Newport City Council – Planning Consultation

Application Number: 25/1056

Proposal: REPLACEMENT OF THE DEMOLISHED DWELLING "BRAMLEY"

Arboricultural Remarks.

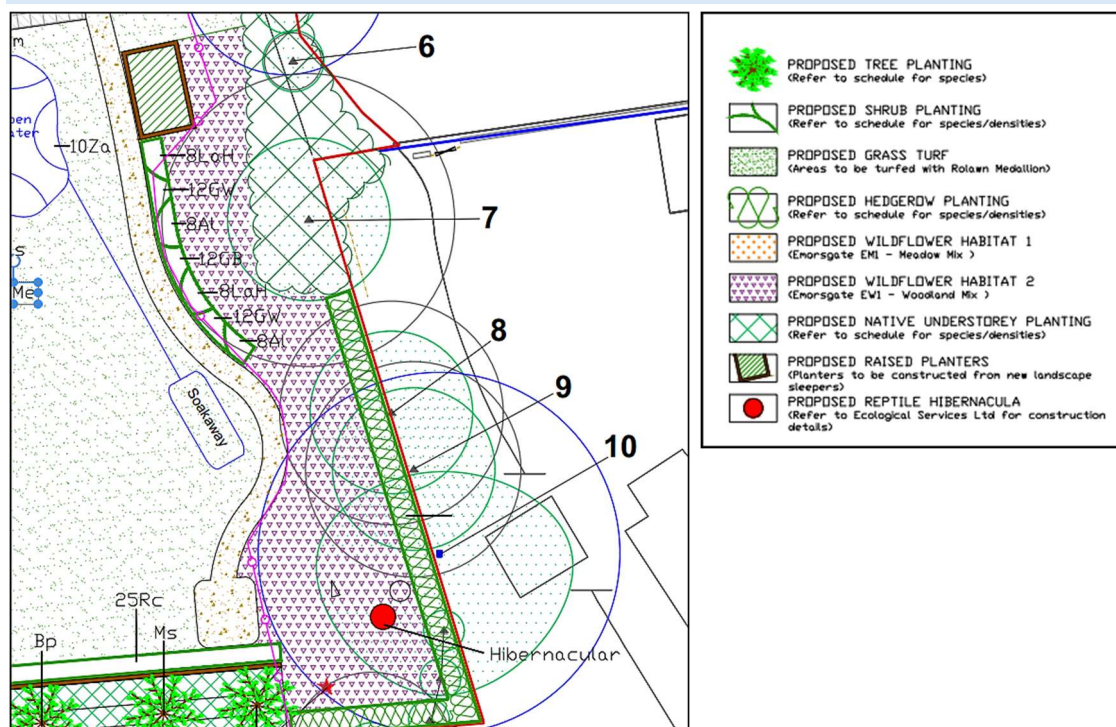
June 2026 - In the updated Arboricultural Implications Assessment / Tree Protection Plan, it is noted that the house position remains in the RPA of H1 and this issue has not been addressed. **An objection remains on arboricultural grounds (refer to plan excerpt below).**

June 2026 – whilst the landscape detail has been provided in the updated Tree Protection Plan, it is noted that there is significant landscape planting within the Root Protection Area of retained trees and this, in principle, is not acceptable, due to the related root damage and competition with existing trees (refer to plan excerpt below). **An objection remains on arboricultural grounds.**
